**PREVOST**ENREGISTRÉ - REGISTERED
ISO 9001 & ISO 14001**WARRANTY
BULLETIN**

Wb07-02

DATE : AUGUST 2007	SECTION : 04 - Exhaust
EXPIRATION: AUGUST 2009	
SUBJECT: INSTALLATION OF AN EXHAUST PIPE REINFORCEMENT BRACKET AT TURBO OUTLET

FIGURE 1: ENGINE COMPARTMENT

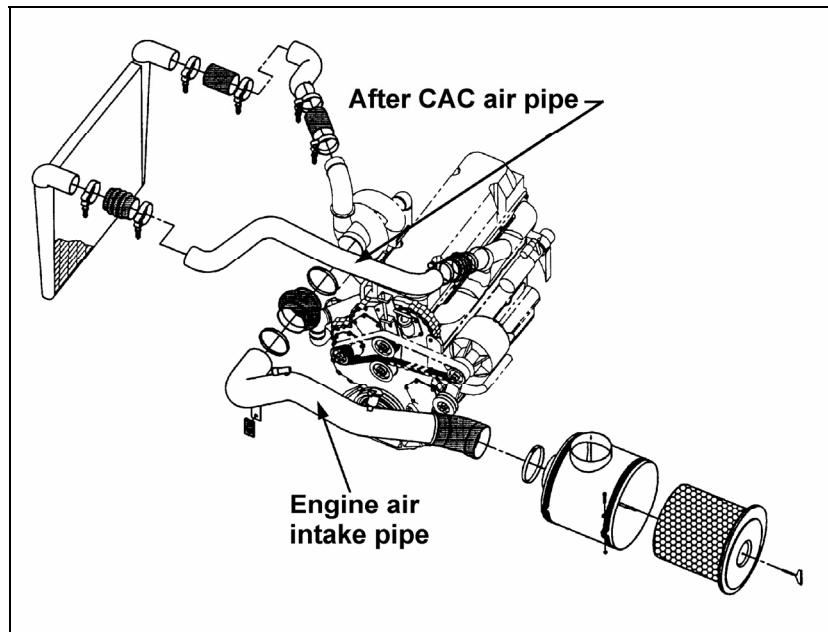
On the above-mentioned vehicles, there is a possibility that the exhaust pipe at turbocompressor outlet breaks due to lack of support or engine vibrations.

3. Remove engine air intake pipe (refer to fig. 1).
4. Remove after CAC air pipe (refer to fig. 1).
5. Remove the two bolts which secure the exhaust pipe.
6. Torque both engine stud bolts (Prévost #510626) to 43 - 54 lbf·ft (58 - 73 Nm). Install new reinforcement bracket (Prévost #040561) and tighten Stover nuts (Prévost #500680) as shown in figure 2.
7. Install U bolt assembly (Prévost #540018) and tighten U bolt nuts.
8. Reinstall after CAC air pipe and engine air intake pipe.
